10682 Banbury Oil Depot

Technical Note 4: Response to EA Drainage Comments: 24th May 2022

Date: 1st August 2022

Flood Extent Plan

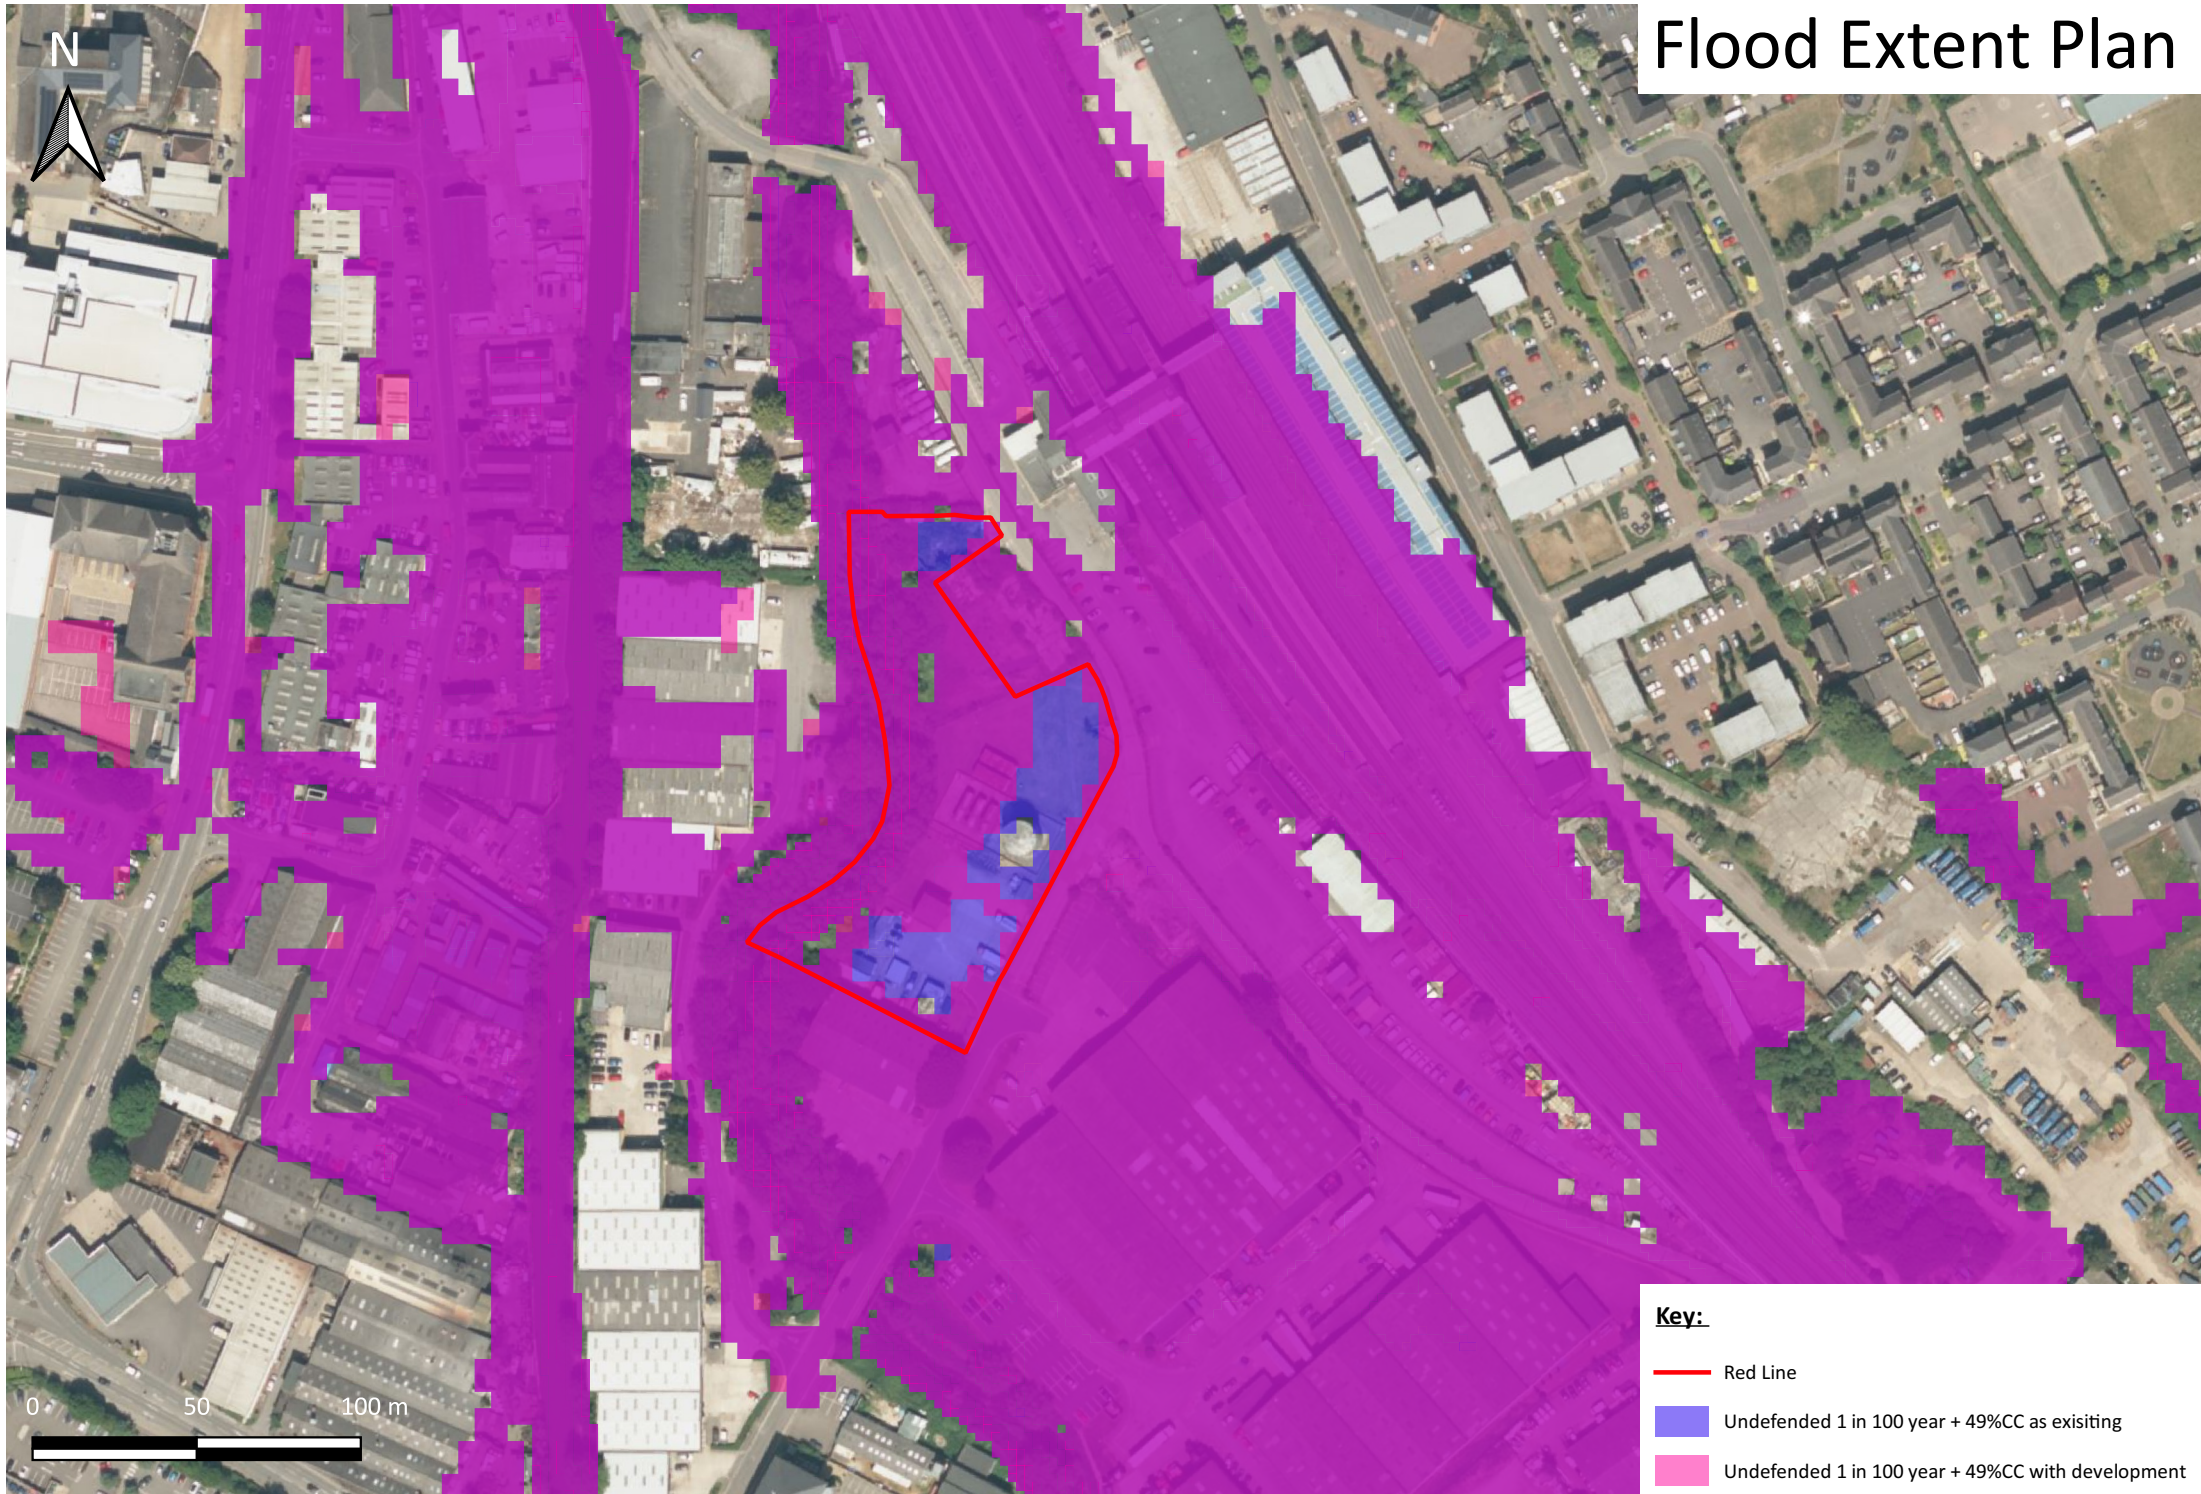
- 2.1 *We reiterate that the FRA should map the expected extents and depths of a range of critical flood events up to and including a 1% annual probability event with an appropriate allowance for climate change in accordance with the following guidance: 'Flood risk assessments: climate change allowances'. More Vulnerable development in flood zones 2 or 3 should use the higher central and upper end allowances. Flood extents should be mapped in accordance with a detailed topographical survey of the site.*

- 2.2 We received the product 5, 6 and 7 packages from the Environment Agency on 11th November 2021. The model received was produced in October 2015 and includes a climate change allowance of 20%.

- 2.3 This model has been run by BCL to accommodate the increase in climate change allowance from 20% to 49%; the upper end value for the 2080's for the Cherwell and Ray Management Catchment peak river flow allowances.

- 2.4 Appendix A of this note is a plan illustrating the flood extents for the 1 in 2, 1 in 30, 1 in 100, 1 in 100 + CC and proposed development and 1 in 1000 with proposed development storm events.

Flood Extent Plan

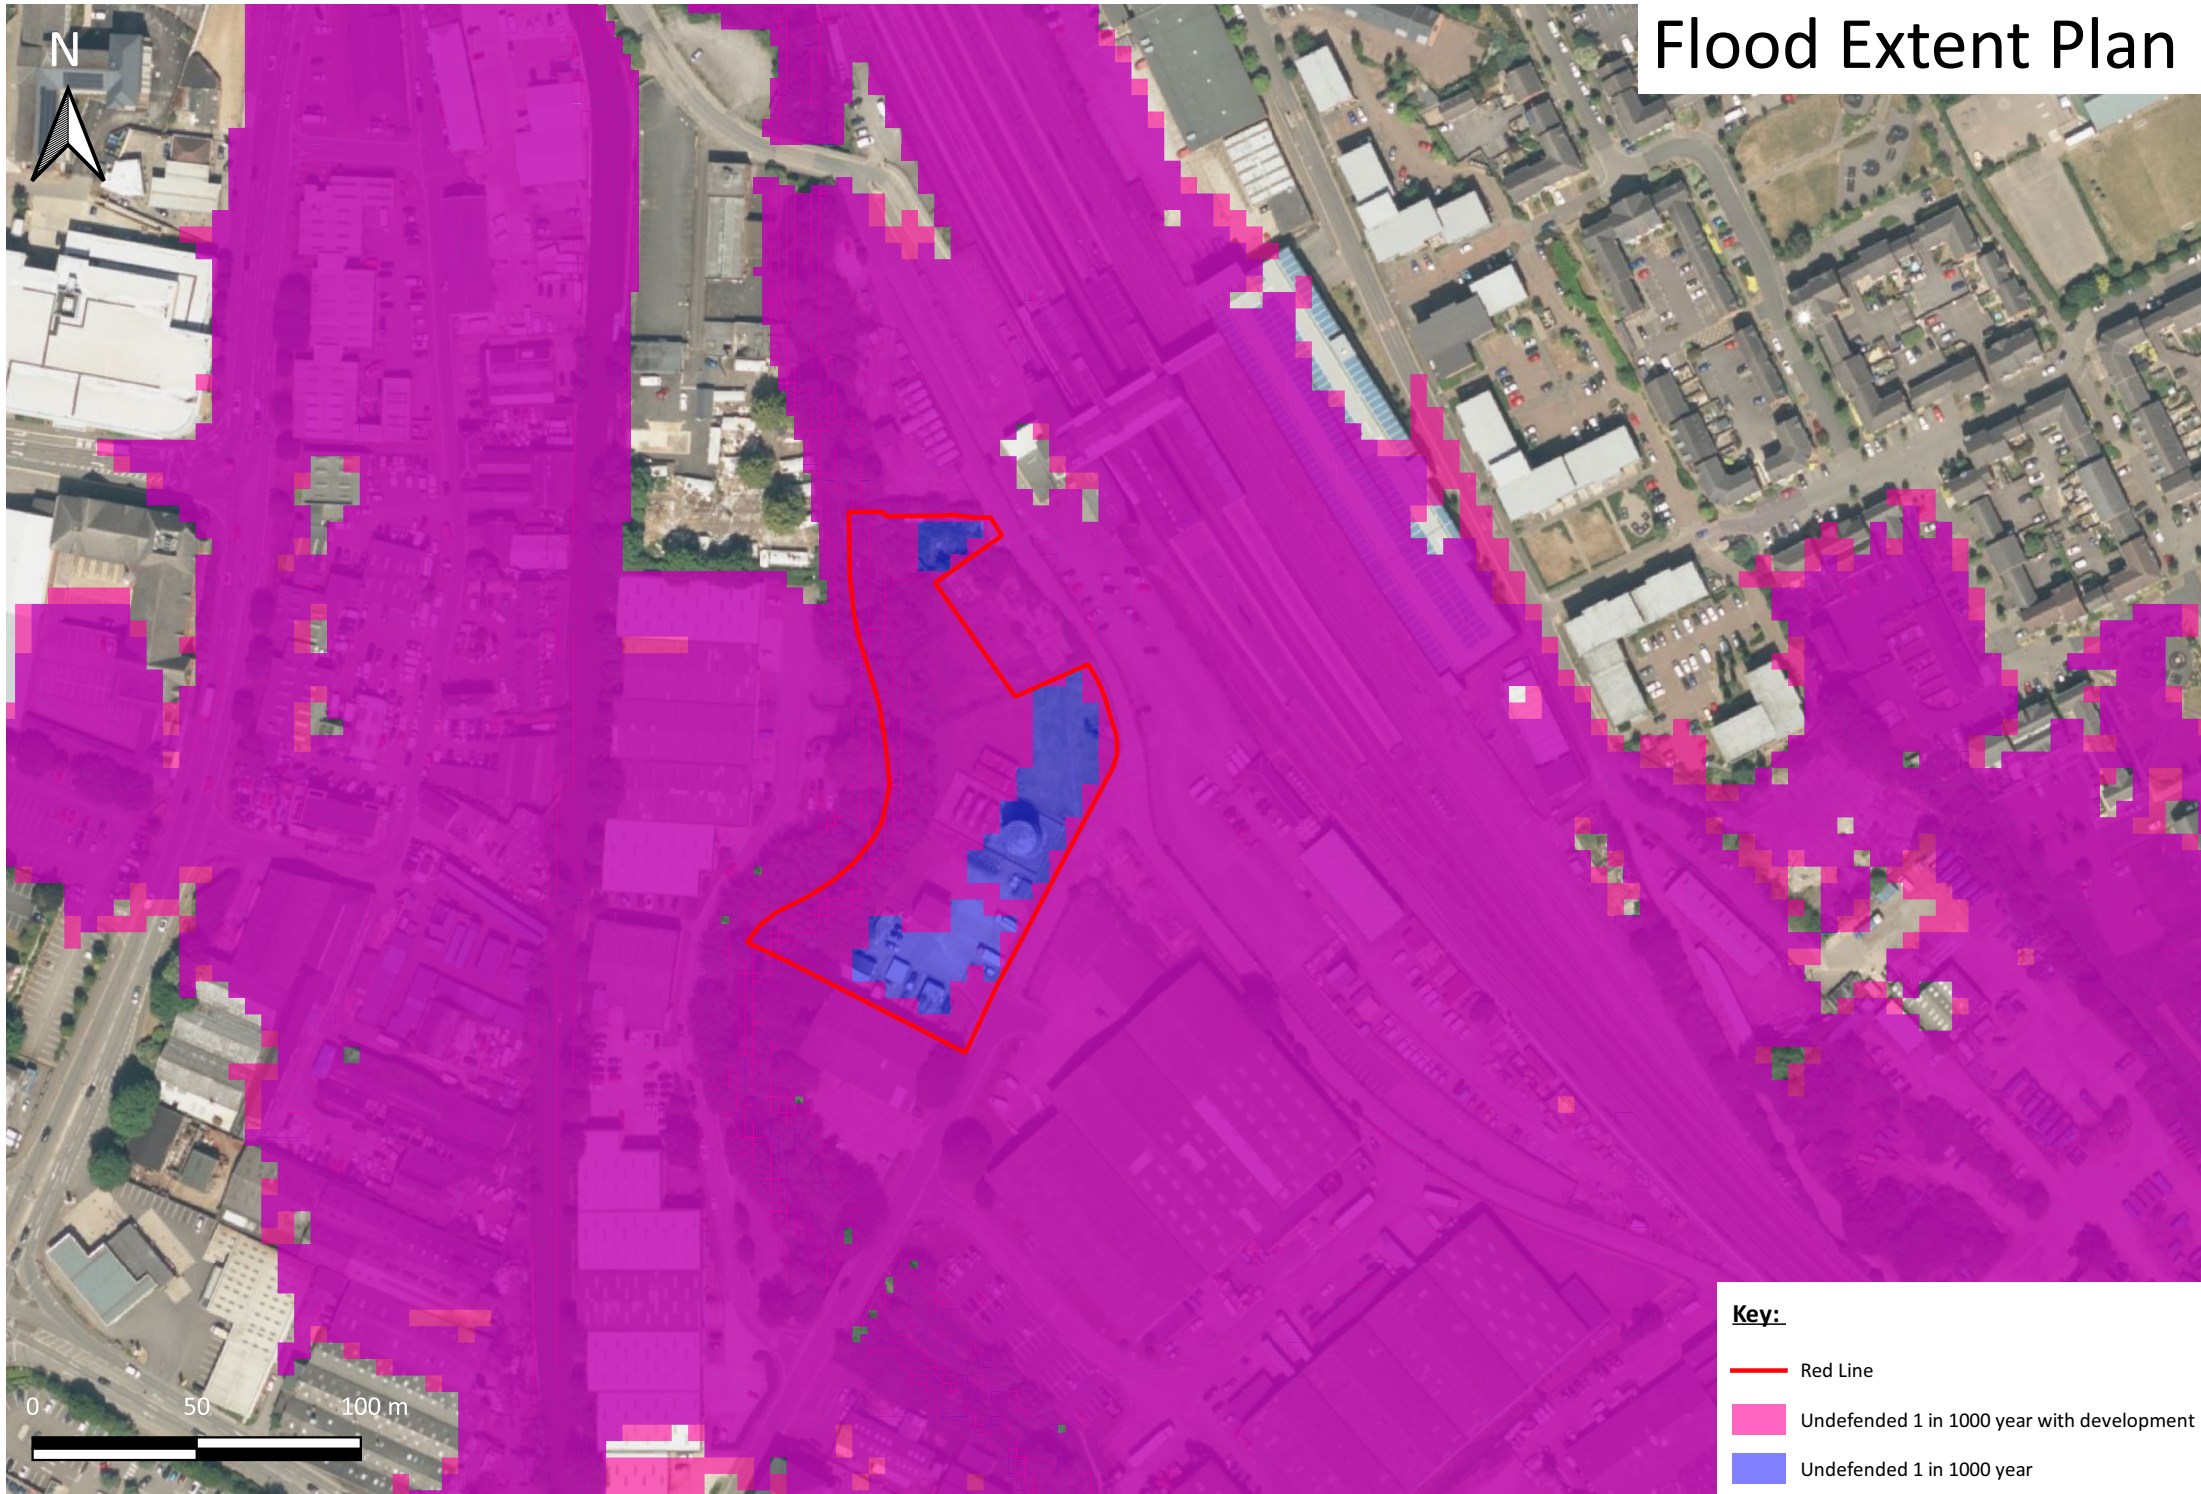
- 2.5 *Based on the proposed illustrative plans for the site, the FRA should identify that any potential loss of flood storage due to the development can feasibly be replaced on site, on land outside of the 1% climate change extent. This is necessary to ensure that the site can accommodate the amount of development being proposed without increasing risk elsewhere and that it is feasible for sufficient space for flood storage to be provided. The FRA must also consider the feasibility of raising internal floor levels above the 1% climate change flood level.*

- 2.6 The EA model was built to a 5m by 5m grid, therefore, should any displacement of water that falls within any area of that grid it will be shown as covering the whole area. The model also does not take into account the area of any existing buildings or structures so it is not clear what the true flood extents are or how the displacement of flood water from this development impacts the flood extent.

- 2.7 The flood model has been run with the area of proposed development (0.247ha) in place. This showed a displacement volume of 704m³ in the 1 in 100 year + climate change storm event and for the 1 in 1000 year storm event a displacement volume of 2,007m³.

- 2.8** However, there are already buildings within the development site (approximately 0.104ha). As the model does not account for these buildings, it can be assumed that 42% of the volume displaced from the proposed buildings (843m³ for the 1 in 1000 year) is already accommodated for outside of the site boundary. This then leaves 1,164m³ for the 1 in 1000 year of displacement created from the development.
- 2.9** Due to the nature of proposed development and the extent of the existing flood plain it is unrealistic that a flood compensation/ mitigation scheme would work within the site boundaries.
- 2.10** As an allocated development within the local plan, there is an acceptance that the proposed flats would be designed and built above the 1% climate change flood level.
